City of Albuquerque

***RE: NETHERLIN HOMES - 8921 W PAN AM FWAY NE (C18-D51). ENGINEER'S
CERTIFICATION FOR CERTIFICATE OF OCCUPANCY APPROVAL.
ENGINEER'S STAMP DATED JANUARY 10, 2000.***

**RE: NETHERLIN HOMES (C18-D51), STREET PAVING PLAN & PROFILE -
Preliminary Street Design, Engineer's Stamp Dated April 13, 1999, supplement to
DRAINAGE REPORT AND Revised GRADING AND DRAINAGE PLAN FOR
BUILDING PERMIT APPROVAL. ENGINEER'S STAMP DATED MARCH 15,
1999.**

**RE: DRAINAGE REPORT FOR NEATHERLIN HOMES (C-18/D-51)
RECEIVED DEC 31, 1998 FOR BUILDING PERMIT
ENGINEER'S STAMP DATED 12-24-98**

RETENTION POND AS EROSION CONTROL :

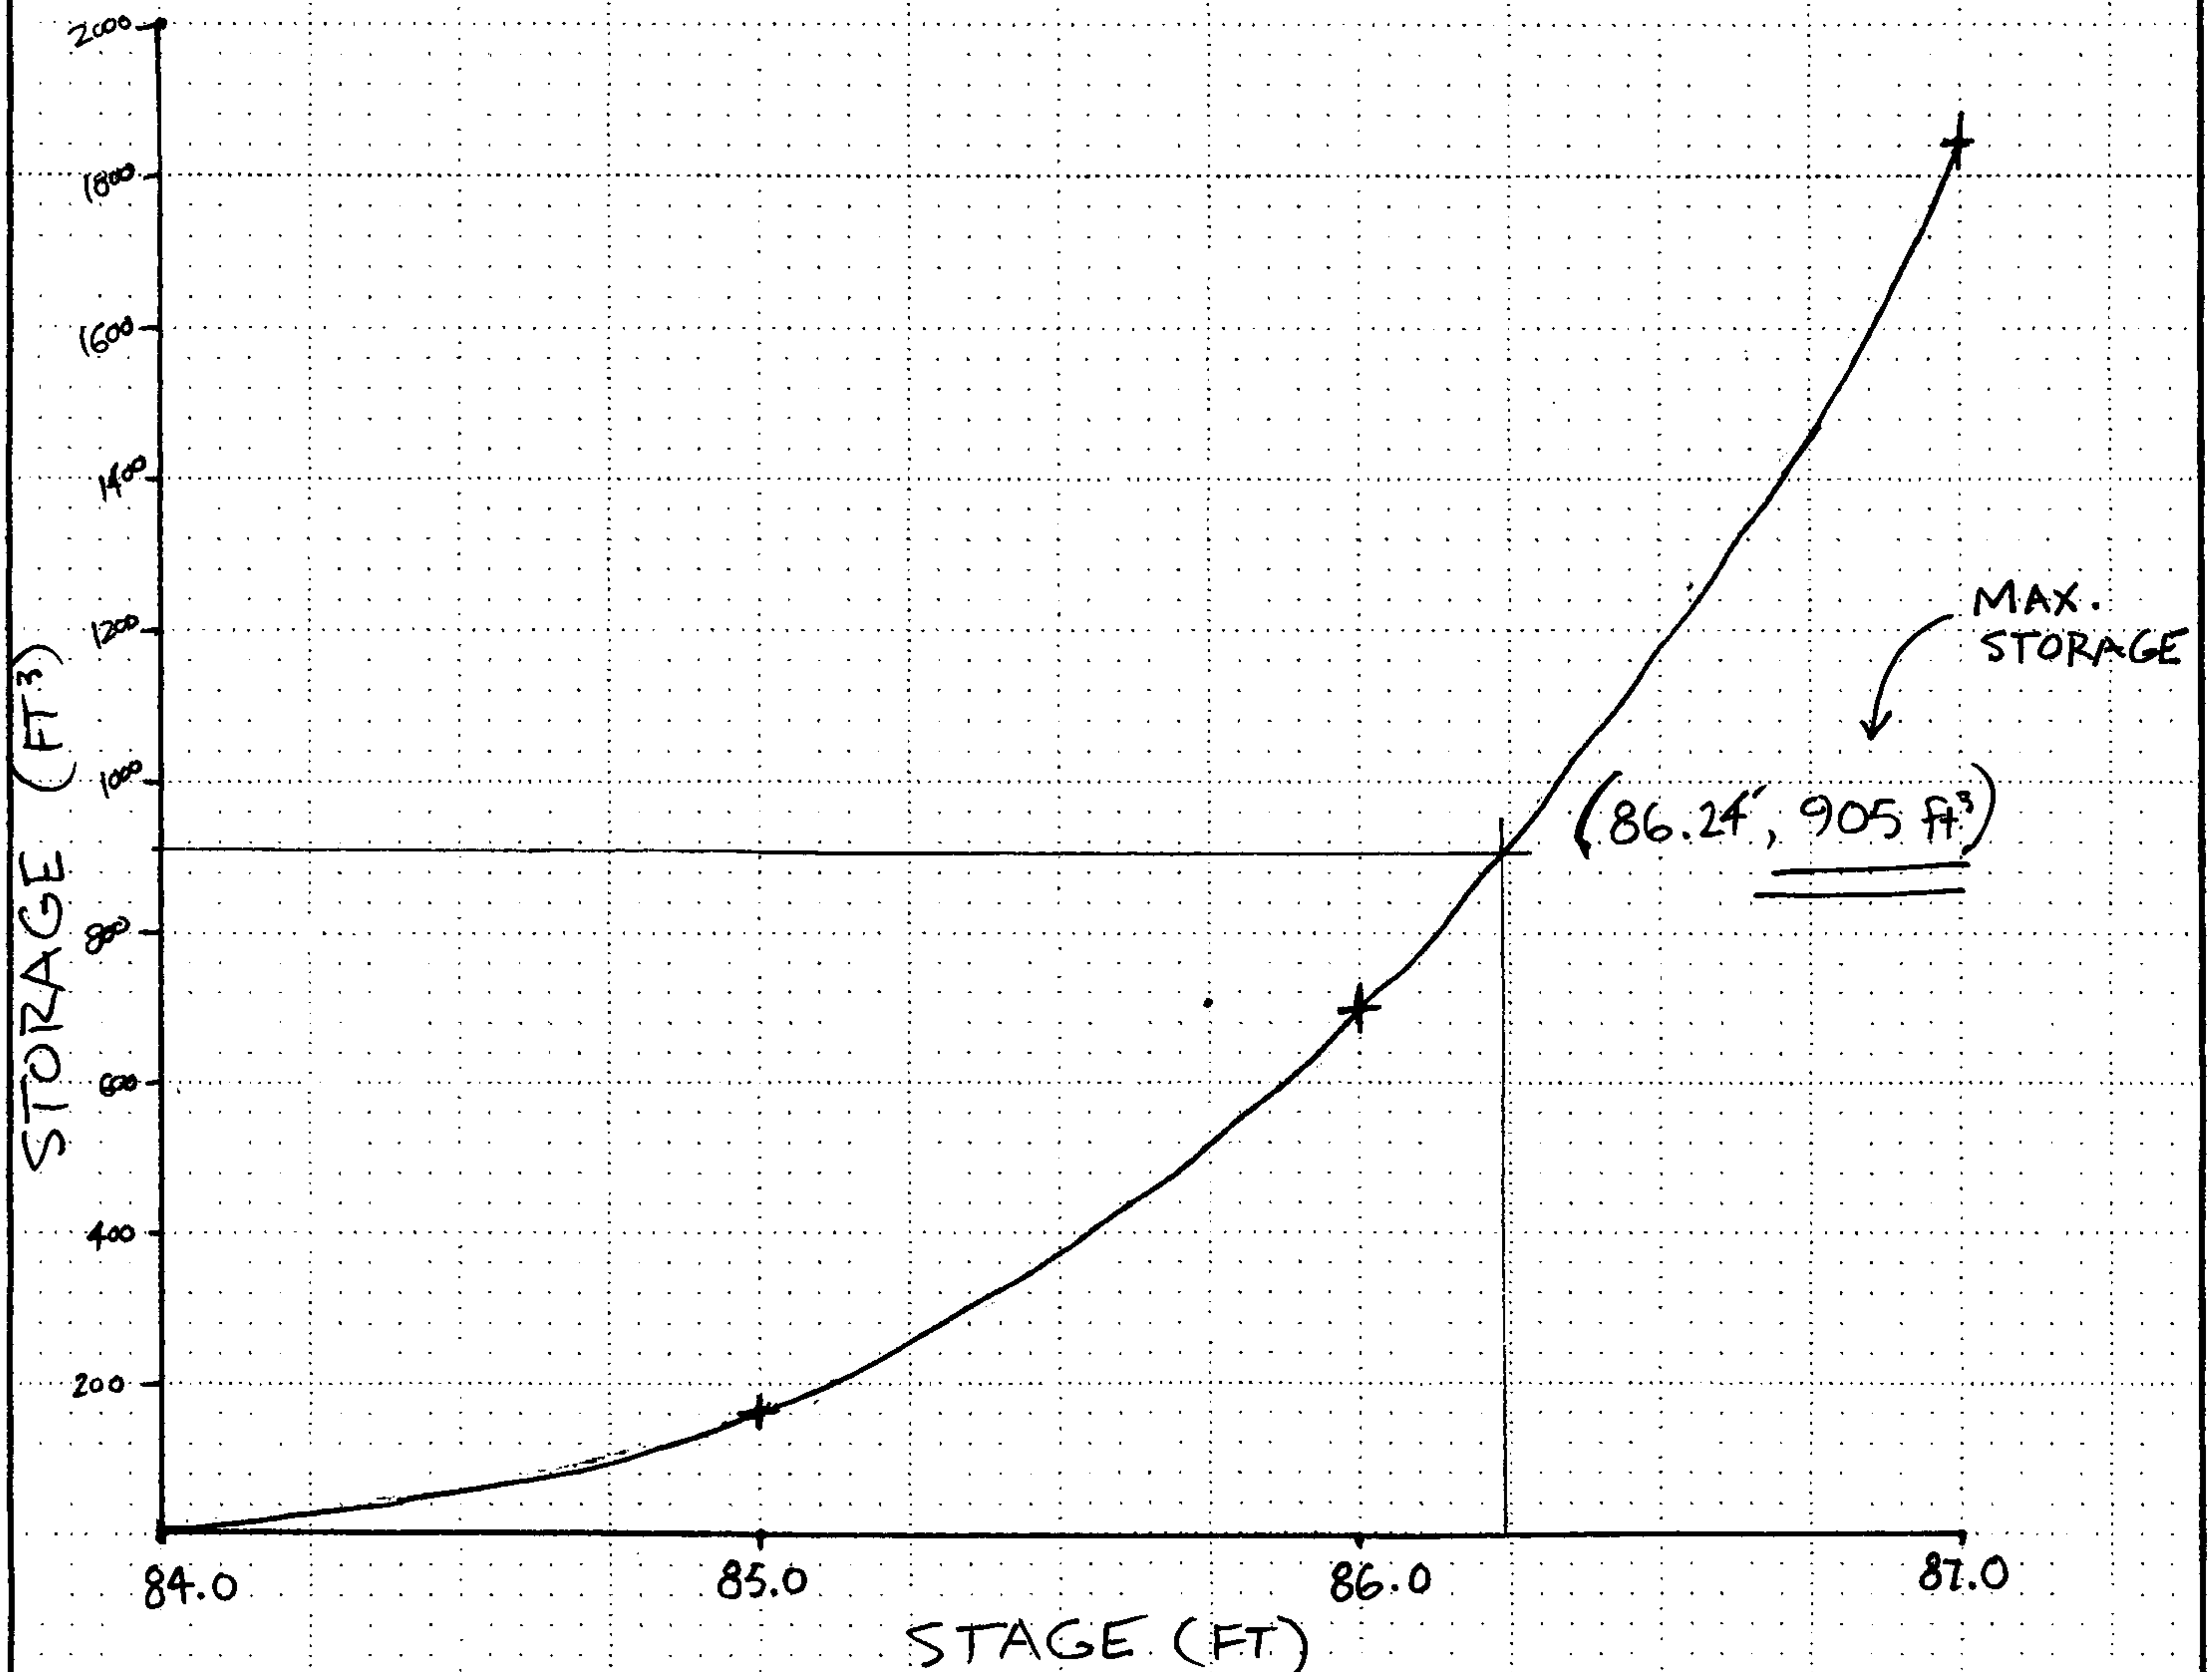
FOR ADEQUATE EROSION PROTECTION IN R/W, POND MUST HOLD 2-YEAR STORM RUNOFF WITH EXCESS CAPACITY FOR PUBLIC WATER (2-YEAR STORM RUNOFF IN EAGLE ROCK R/W).

∴ ATTEMPTING TO USE POND AS EROSION CONTROL WILL INCREASE EROSION FLOWS IN R/W AS 466.78 FT³ OF ON-SITE WATER WOULD BACKFLOW ONTO EAGLE ROCK DR.

Since the construction of downstream improvements (by others) is in progress, the reduced pond capacity should suffice for the interim.

DRAINAGE BASINS

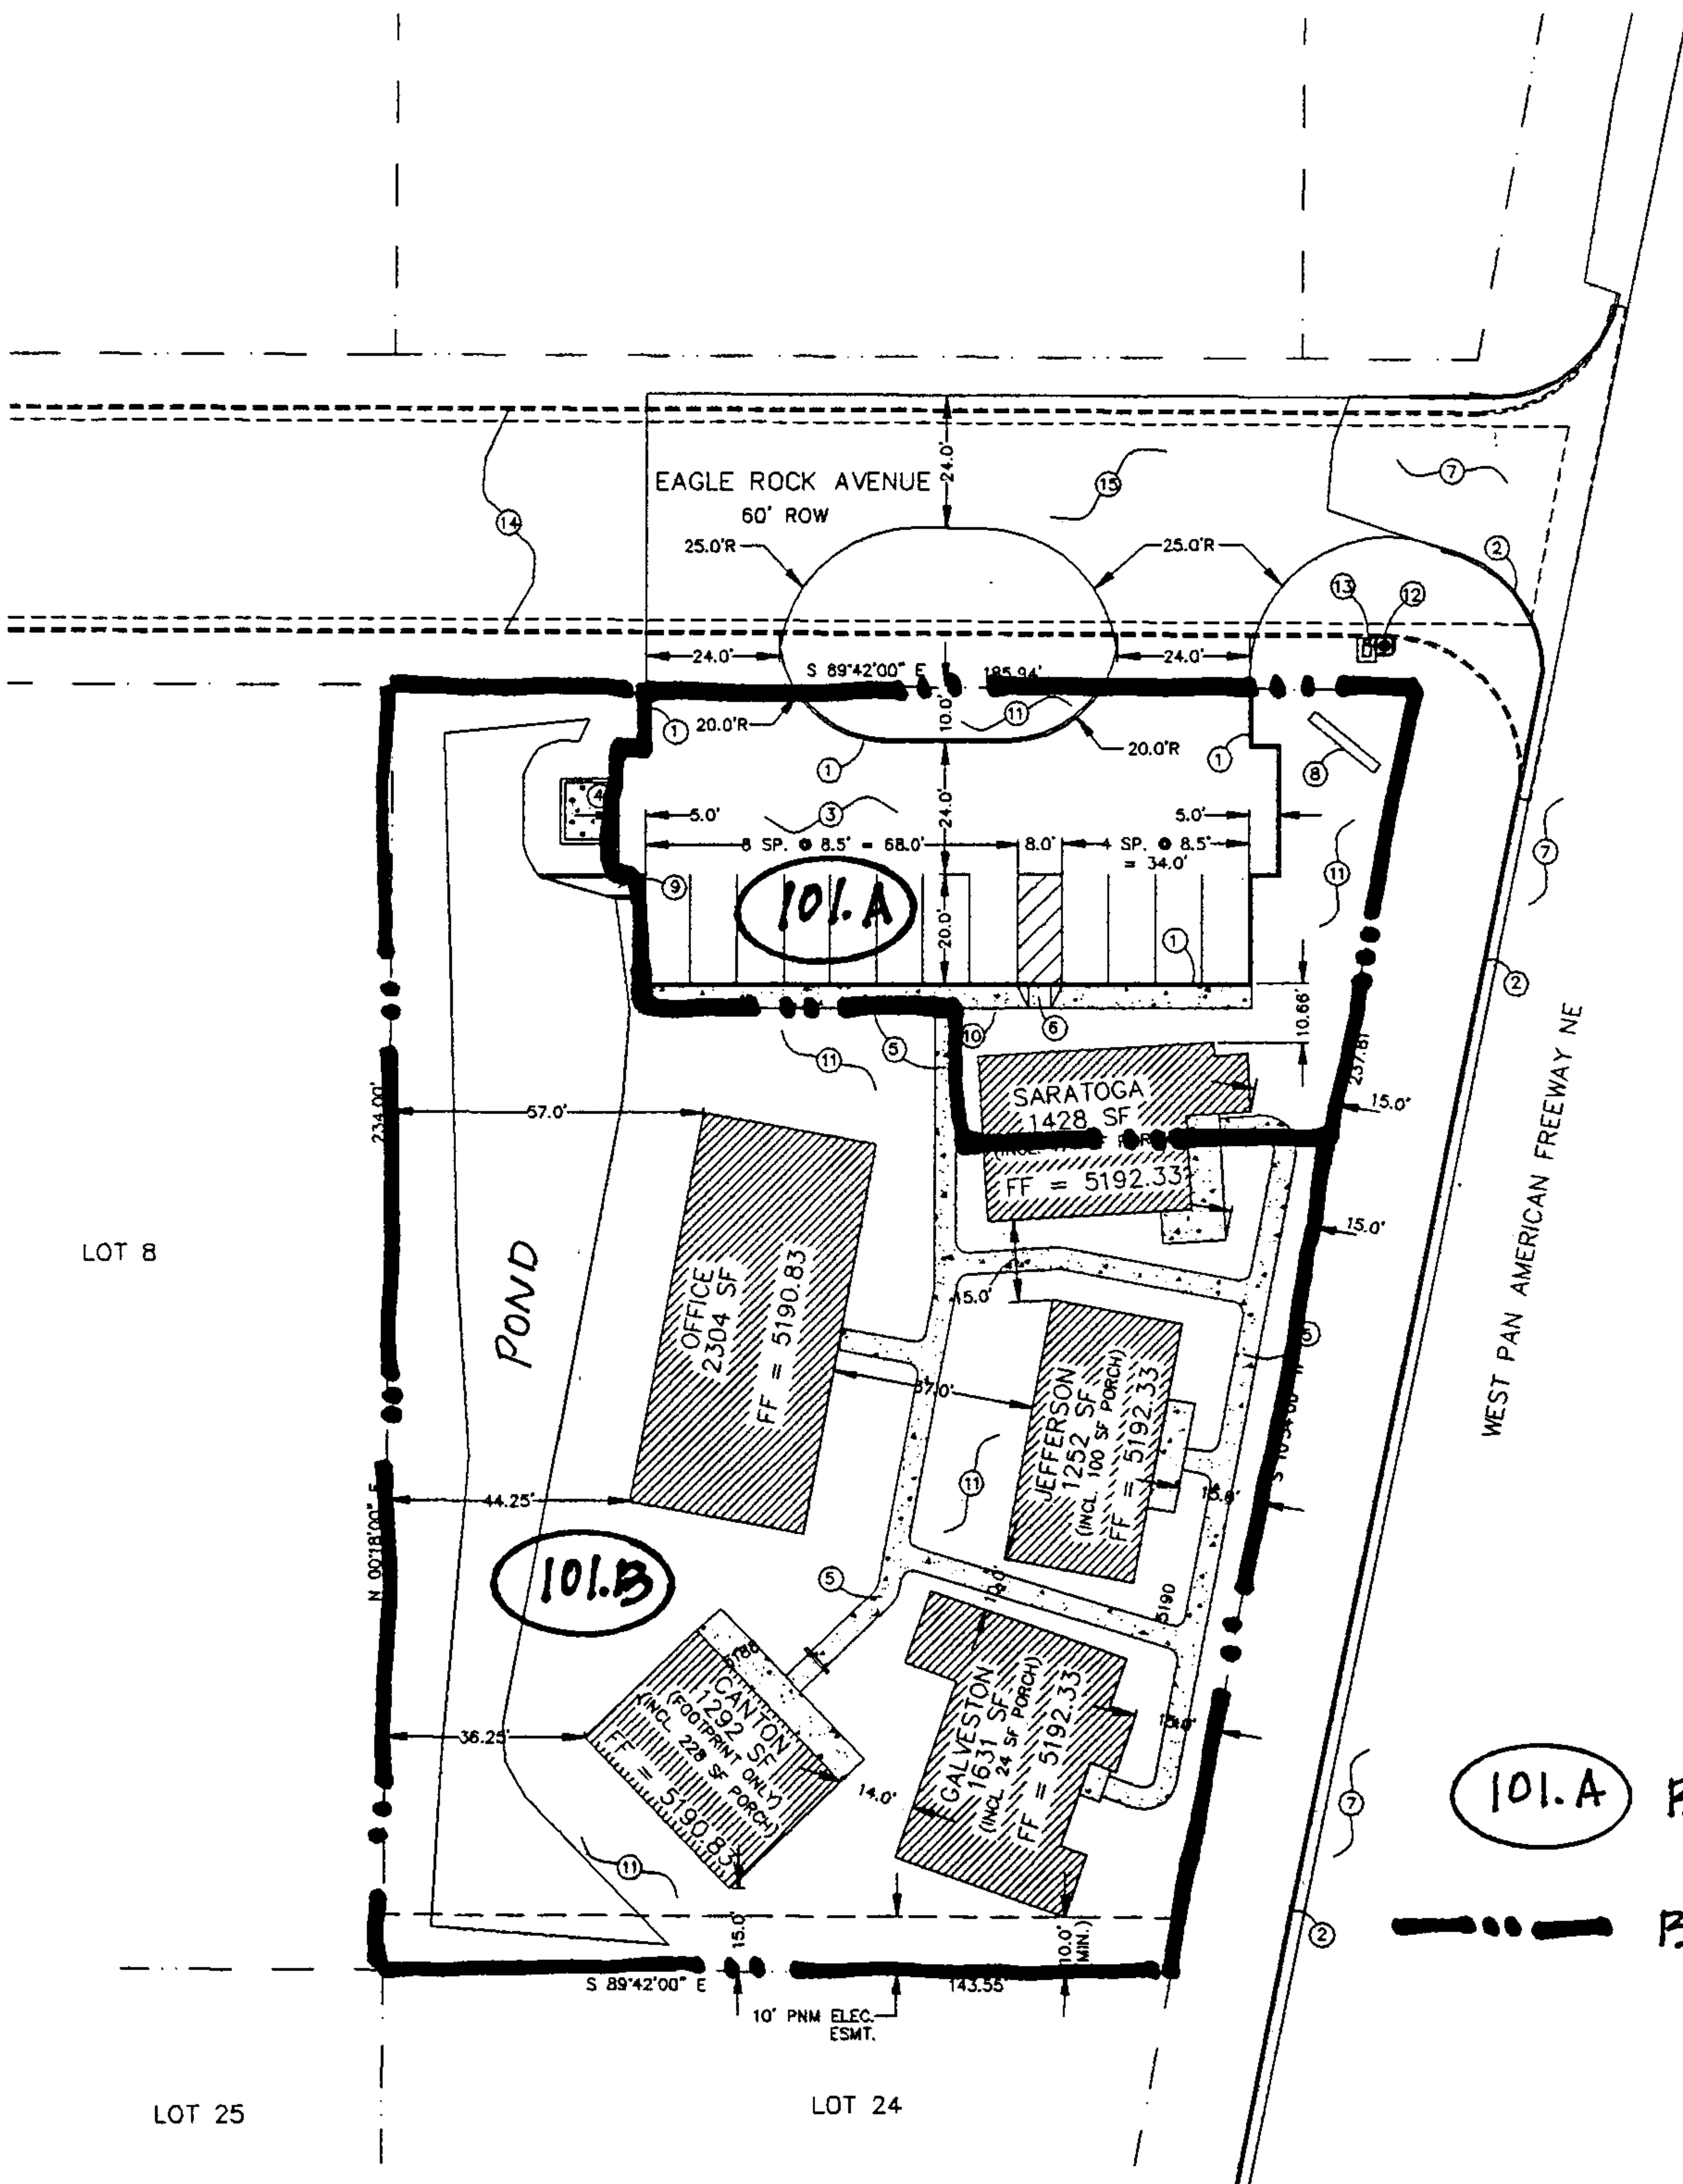
Provide a copy of the infrastructure list. How will the Eagle Rock storm drain be built? Why are you proposing temporary street paving instead of permanent improvements? How did you determine street grades for Eagle Rock? The two lots need to be combined into one. Why is the developed basin 100 only 0.8 acres?

The Erosion Control Notes must be on the Plan instead of in the Report. A water block is required on Eagle Rock to prevent runoff from the frontage road from entering Eagle Rock. It appears that runoff will puddle along the west edge of paving on Eagle Rock. Runoff from Eagle Rock must be drained into the pond. Concrete rundown should extend to bottom of pond to prevent slope erosion.
